Roland Lebrun
ccss@msn.com
Brisbane Baylands Draft EIR
January 19 2014

Thank you for the opportunity to comment on the Brisbane Baylands Draft EIR.

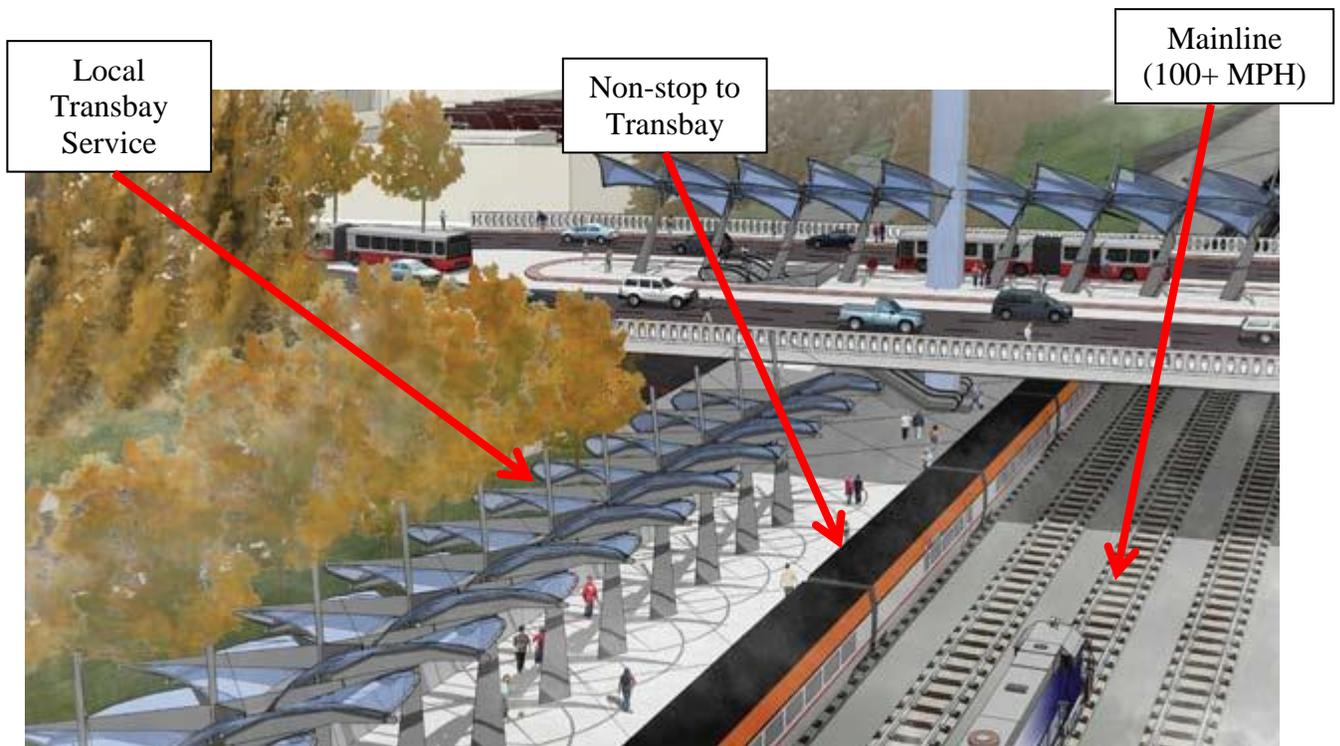
It is in this context that the DEIR should consider a new rail alignment capable of supporting speeds in excess of 100 MPH along the proposed future 5th Street.

The relocation of the tracks and the Bayshore station to the 5th Street alignment would also significantly enhance transfers between Caltrain and the proposed Muni T-Third light rail station on 5th Street.

The relocated Bayshore station would have two additional tracks to facilitate cross-platform transfers between Baby Bullets (5-minute non-stop to Transbay) and locals stopping at Oakdale, 22nd Street, Mission Bay and the Transbay Terminal. The additional station and turnaround tracks would support a capacity of 12 trains/hour between Brisbane and Transbay, 10-20 years ahead of the rest of the Peninsula (Policy 6-12).

The impacts caused by the higher speeds of express trains should be mitigated by creating embankments on both sides of the tracks thereby giving the impression that the proposed Geneva Avenue extension is at grade while the platforms and the tracks are in a trench.

Platform lengths.

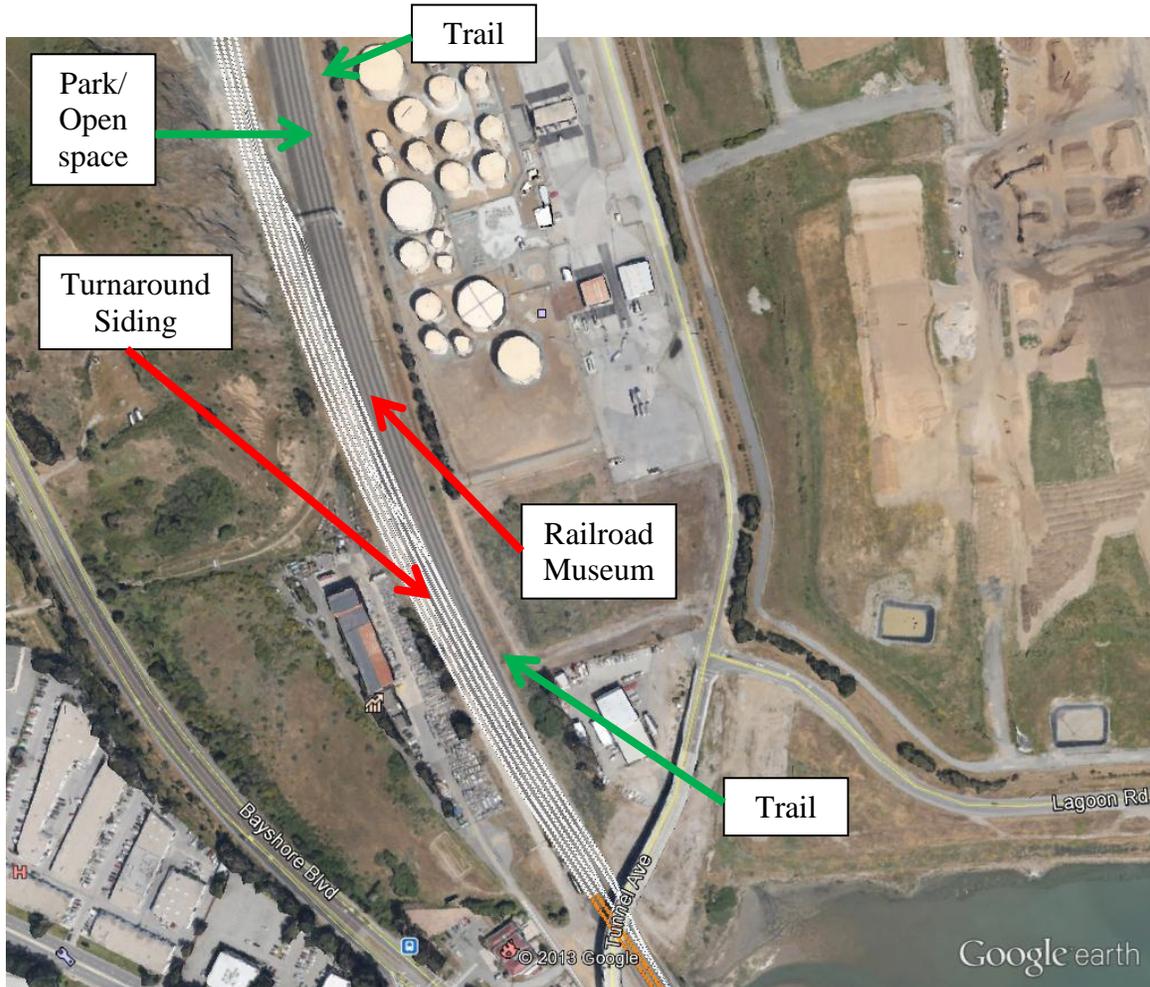
Please refer to "Platform Dimensions" on page 13 of Chapter 3 of the Caltrain Engineering Standards: <http://www.caltrain.com/assets/engineering/engineering-standards-2/criteria/CHAPTER3.pdf> : *"The standard platform length shall be 700 feet to accommodate a six (6) car train consist. **Platform design shall consider or not preclude a possible expansion of platform length to 1000 feet**"*

The DEIR should consider this 1,000-foot requirement because it would enable a Bayshore Caltrain station entrance at Beatty Avenue which is within walking distance of the Schlage Lock development. The DEIR should also consider extending the platforms south of Geneva Avenue to match Transbay's 1,330-foot platform lengths for two reasons: support for double-length Caltrain consists capable of transporting 2,000 passengers to/from special events in downtown San Francisco and/or Brisbane and the ability to disembark and turn around full-length HSR trains in case of an emergency between Brisbane and the Transbay terminal.
